## Confirmation Notice

| Application No:            | OPW/25/0002                                                                                                                                                                           |
| Proposal:                  | Development Permit for Operational Works – Roadworks, Earthworks, Stormwater Drainage and Water Reticulation for Wylandra Stage 1 (14 Lots) and Associated Stormwater Detention Basin |

A further Information Request is made by the assessment manager as detailed below:

*Junction of Box Culverts – Extract from Erscon Drawing 160-010-SK01*

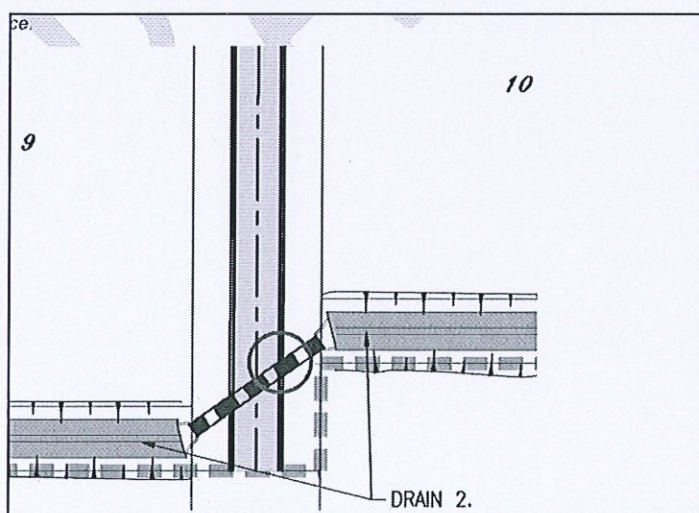
2. Review the time of concentration adopted (and hence critical rainfall intensity) for External Catchments 1, 2 and 3 as shown on Sketch 160-010-SK02. This is to ensure that the calculated peak flows from the catchments represent the runoff likely to be experienced by the receiving infrastructure.

The flow paths adopted to determine the time of concentration must be representative of the majority of the catchment to avoid inadvertently creating a design scenario where the partial area effect for sub-catchments would create a higher design flow.

Updated peak flow calculations for the external catchments are to be provided with the information request response.

*Advice Note: The Catchment 1 flow path shown on Sketch 160-010-Sk02 and time of concentration calculations in the application's supporting documents are not considered to reflect the likely catchment response for the majority of the catchment.*

*Reference is made to the networks of roads, kerbs and formed open drains through the existing developed area where the dominant flow conveyance will be via concentrated flow path with higher velocities and a more direct flow path to the downstream (Stage 1) infrastructure.*

*Updated peak flow calculations are to be provided assessing the more direct flow path or assessing the partial area effect for the catchment serviced by direct flow paths.*
